UC Santa Cruz Building Seismic Ratings
P.E. Fitness Center

CAAN #7726

Rating summary	Entry	Notes
UC Seismic Performance Level (rating)	V (Poor)	
Rating basis	Tier 1	ASCE 41-17 ¹
Date of rating	2019	
Recommended list assignment (UC Santa Cruz category for retrofit)	Priority A	Priority A =Retrofit ASAP Priority B=Retrofit at next permit application
Ballpark total construction cost to retrofit to IV rating ²	Medium (\$50-\$200/sf)	See recommendations on further evaluation and retrofit.
Is 2018-2019 rating required by UCOP?	Yes	Building was not previously rated
Further evaluation recommended?	Yes	Focus on brace gusset connections, vertical geometric irregularity, and potential torsional irregularity

Typical Braced Frame Connections (Note Details 8 and 12 show 5/16 fillet weld from gusset plate to top beam flange)

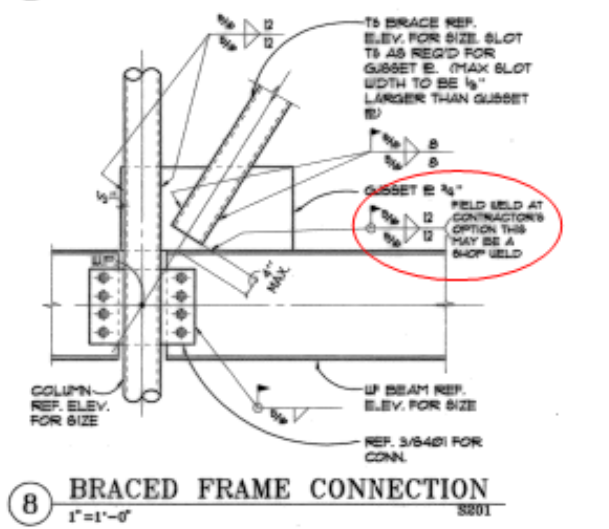
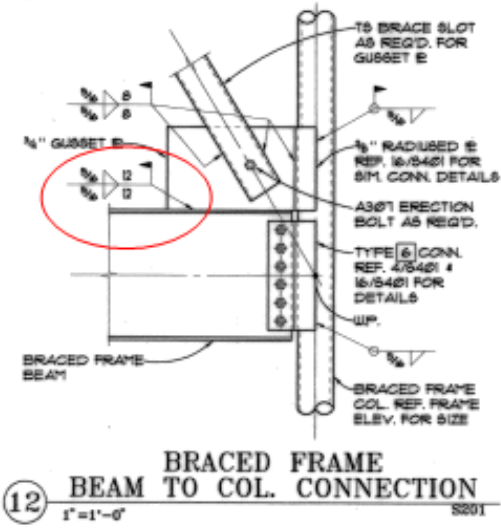
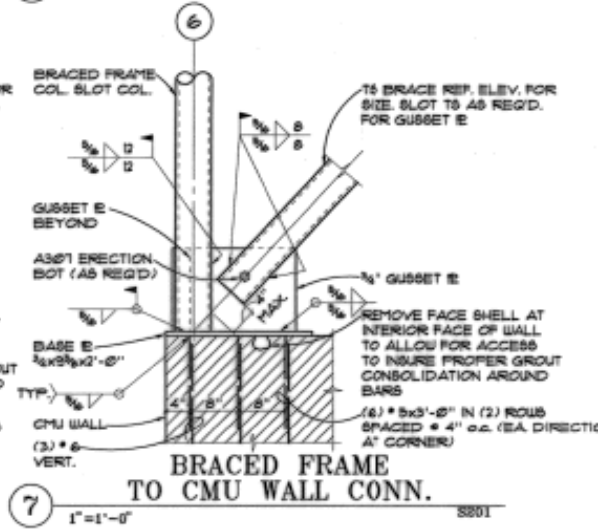
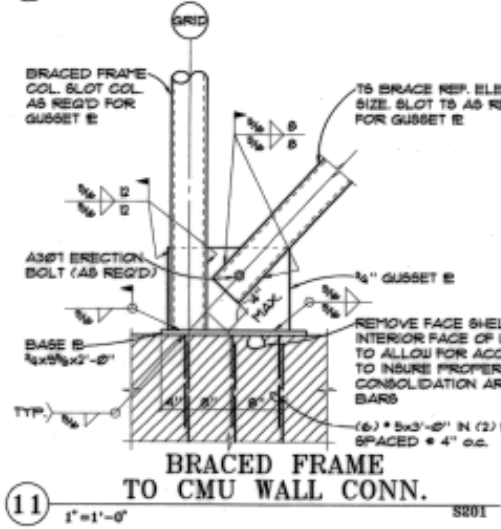
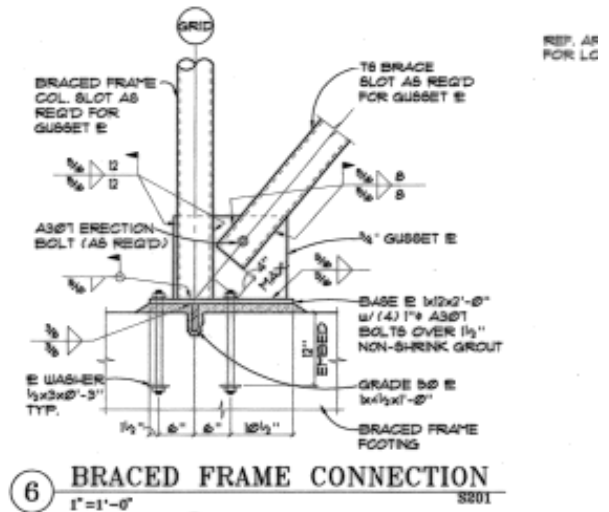
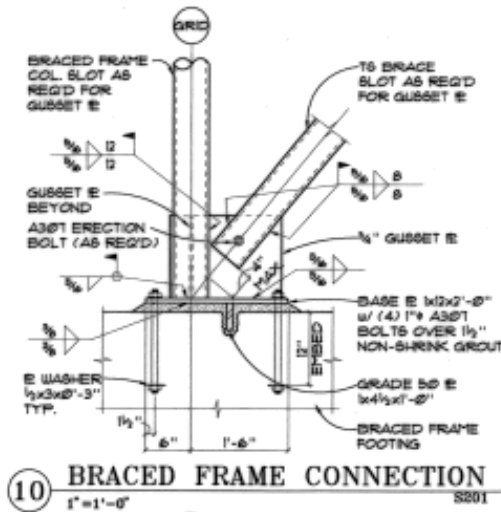
- The braced frame connections were not built as shown on the structural drawings. The 5/16 double fillet from the gusset to the top flange of the beam was missing on both sides of the corner column at one location we observed (see photo in Appendix A). This severely limits the capacity of the braced frames.
- At the second floor, in 5C-6C grid, the seismic force-resisting system changes from a one-bay braced frame to 10" x 71.5 ft CMU wall. This occurs at B.2-C also. Per ASCE 41-17, geometric irregularities can affect the dynamic

- The end connections are not adequate to resist the develop the yield strength of the braces.
- Beams intersecting braces do not have the adequate flexural strength to resist the unbalanced vertical load generated by the braces.
